PLANNING AMENDMENTS

Client _____
RFU _____
Project _____
TWICKENHAM STADIUM EAST STAND EXTENSION
Drawing title _____
LEVEL 5A PLAN - NORTH

Doc ref	Project number	Drawing number	Revision
100-KSS-DR	15735	153	P02

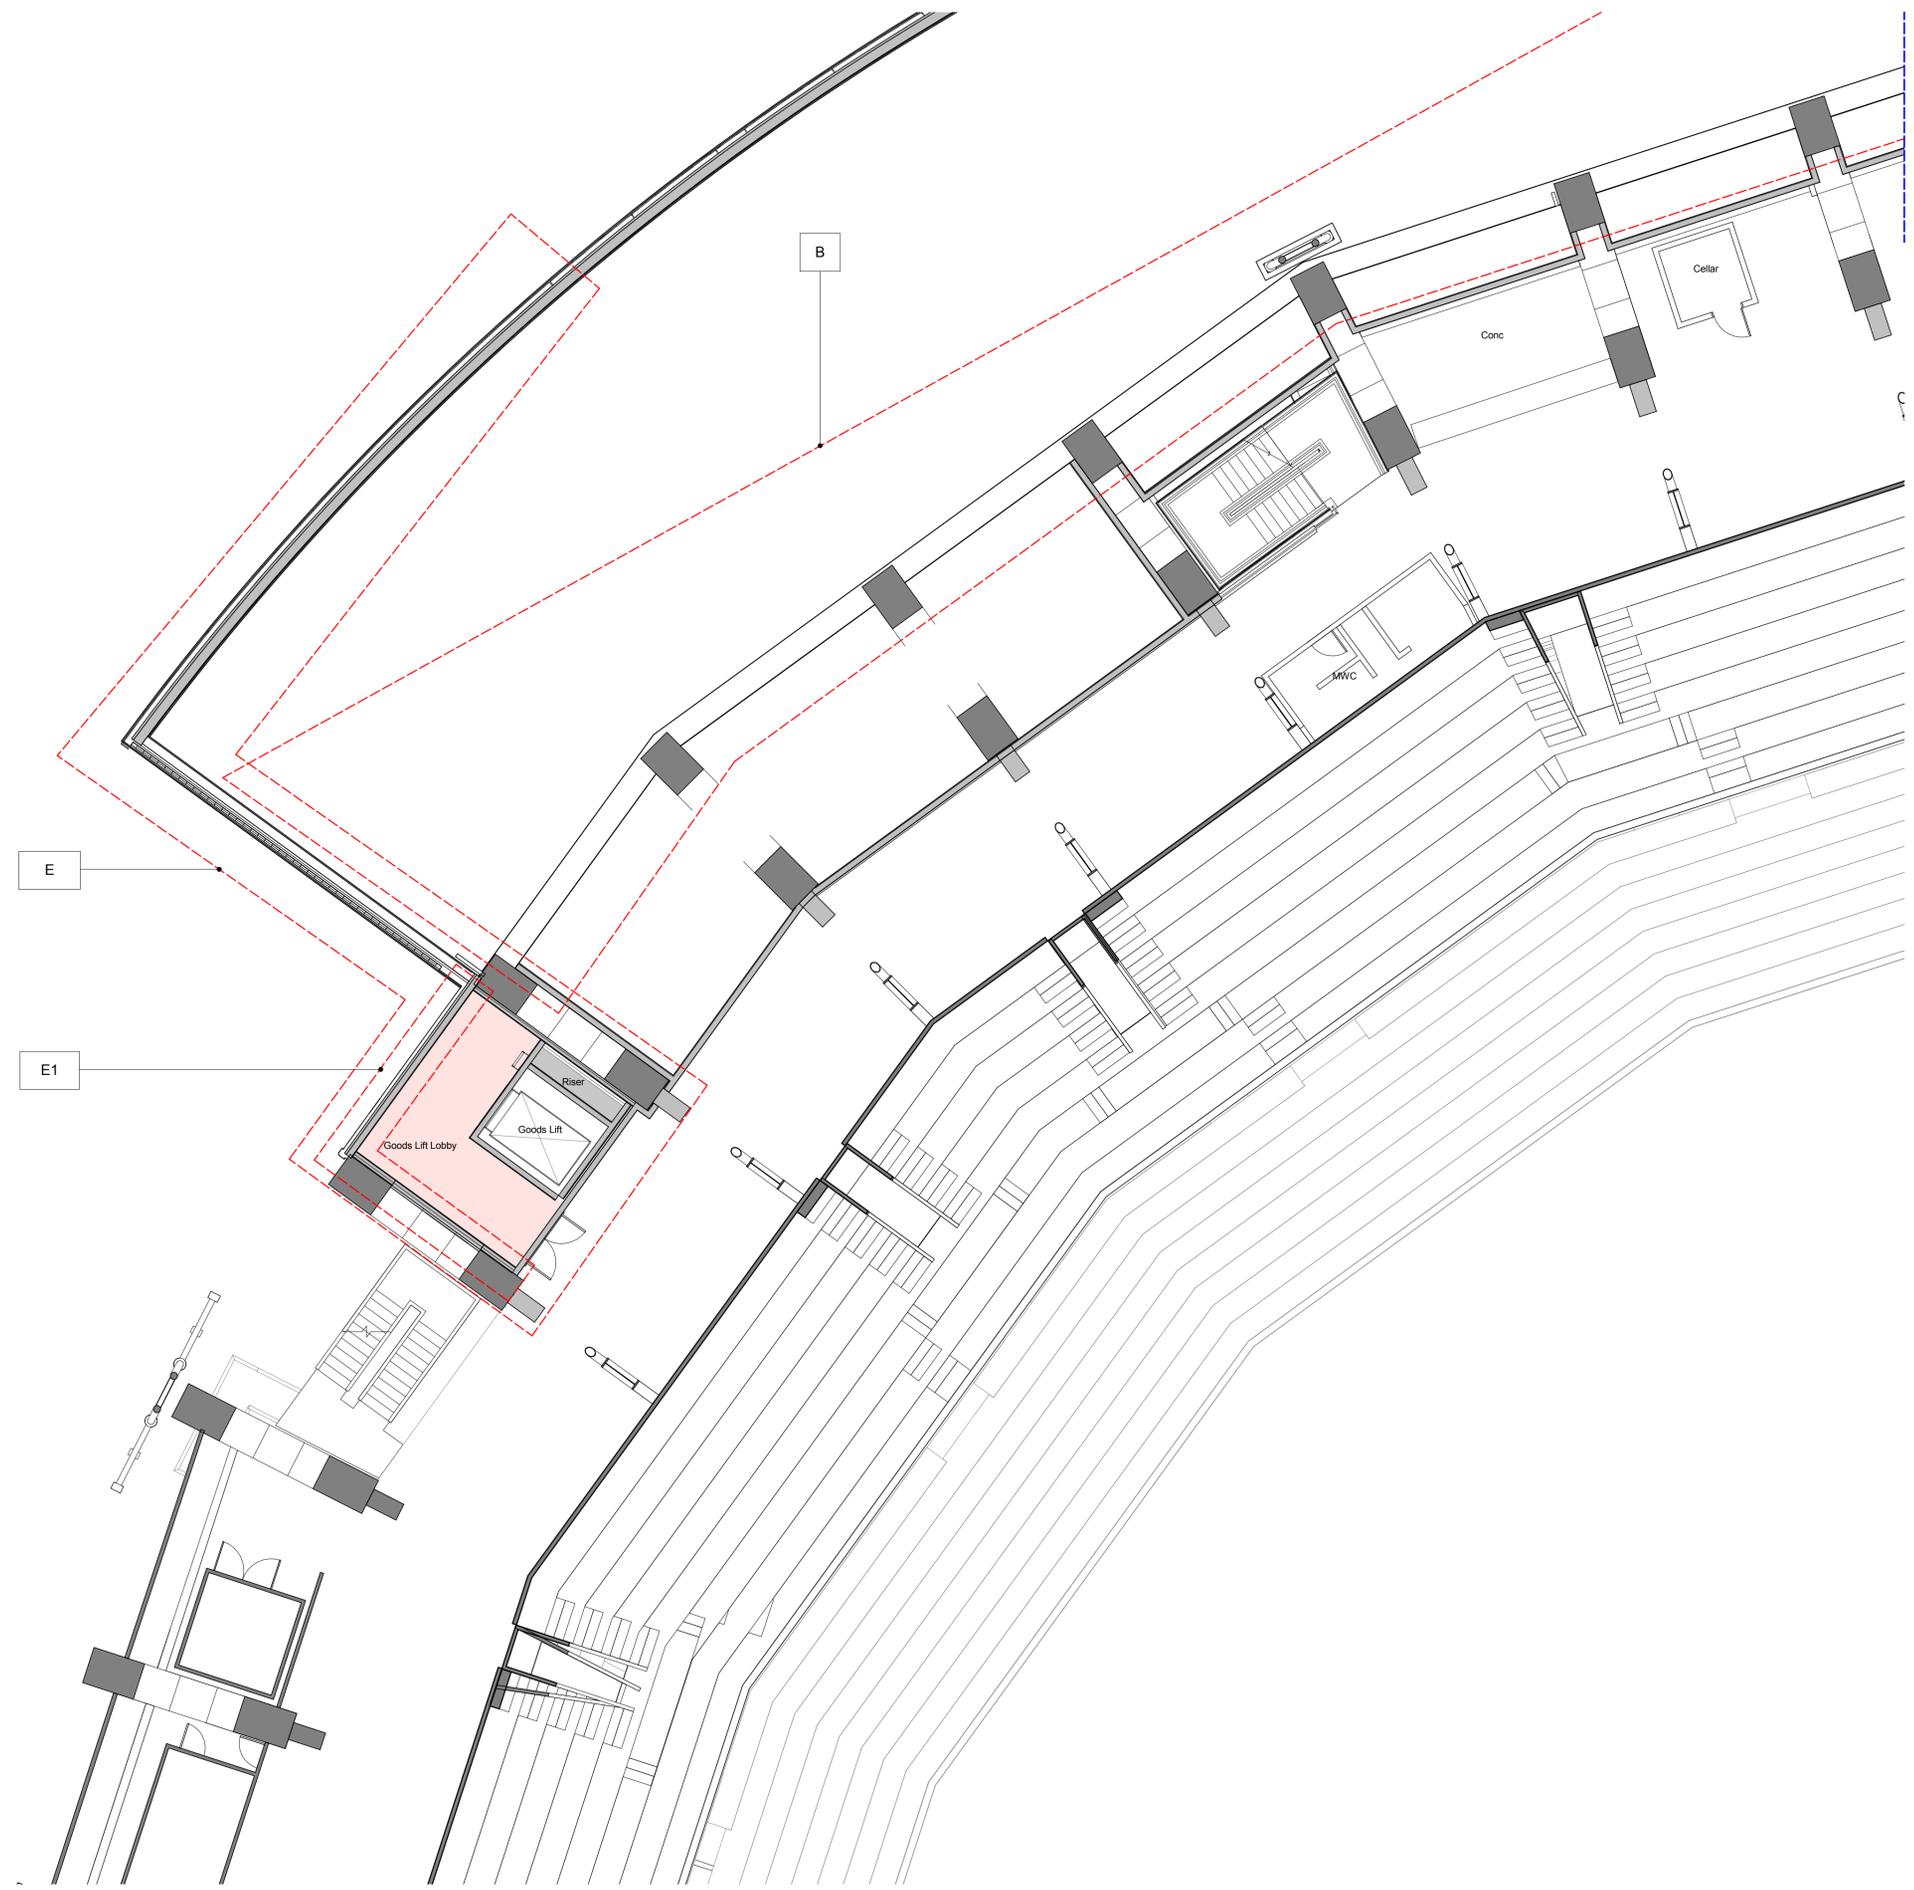
- A GENERAL AMENDMENTS TO THE SOUTH END.
- A1 INCREASED SHINGLES CLADDING AREA AND CURTAIN WALL REDUCED ACCORDINGLY.
- A2 REDUCED MASSING AND REVISED INTERFACE WITH THE SOUTH STAND.

- B PPC LOUVRES LOCATED TO THE BOWL SIDE HAVE BEEN OMITTED.
- C CURTAIN WALL SETTING OUT REVISED GENERALLY. SILICONE JOINTS TO TRANSOMS AND MULLION REPLACED WITH CAPPED SYSTEM. LEVEL 04 PPC LOUVRES SETTING OUT & HEIGHT REVISED. MONORAIL FOR ABSEILING REMOVED.

- D GENERAL AMENDMENTS TO THE CENTRAL ELEVATION CANOPY AT LEVEL 5A REVISED GENERALLY AND STANDING SEAM REPLACED WITH SINGLE PLY MEMBRANE. SUPPORT COLUMNS TO ROOF CANOPY REVISED. SQUARE FASCIA TO ROOF EDGE.

- D1 LEVEL 5A GLAZED SCREEN EXTENDED IN HEIGHT AND PPC LOUVRES INCLUDED AT LOW LEVEL.
- D2 INCREASED SHINGLES CLADDING AREA AND CURTAIN WALL AREA REDUCED ACCORDINGLY. FOUR VERTICAL FINS REMOVED.

- D3 PORCELAIN PANELS WITH SLOTTED HOLES FOR VENTILATION REPLACED WITH PPC LOUVRES. EXPRESSED HORIZONTAL PATTERN TO PORCELAIN PANELS OMITTED.
- E GENERAL AMENDMENTS TO THE NORTH END

- E1 PORCELAIN CLADDING REPLACED WITH PPC ALUMINIUM CLADDING.
- E2 GREEN WALL TO THE NORTH END EXTENDED AND PPC LOUVRES REMOVED.
- E3 INCREASED SHINGLES CLADDING AREA AND CURTAIN WALL REDUCED ACCORDINGLY.

- F FENCELINE, GATE AND PERIMETER COLUMNS SETTING OUT REVISED.
- F1 CANOPY TO TURNSTILES REVISED.
- G PORCELAIN PATTERN CHANGED FROM HORIZONTAL TO VERTICAL.

- H PORCELAIN PANELS TO THE SOFFIT OF THE ARCH REPLACED WITH PPC ALUMINIUM PANELS. PORCELAIN PANELS SETTING OUT REVISED.
- K ROOF TO LEVEL 5A (NORTH END) EXTENDED.

- L GLAZED SPANDREL PANELS REPLACED WITH METAL SPANDREL PANEL. PORCELAIN PANELS REPLACED WITH PPC ALUMINIUM CLADDING.
- L1 PPC LOUVRES INCLUDED FOR MECHANICAL VENTILATION.
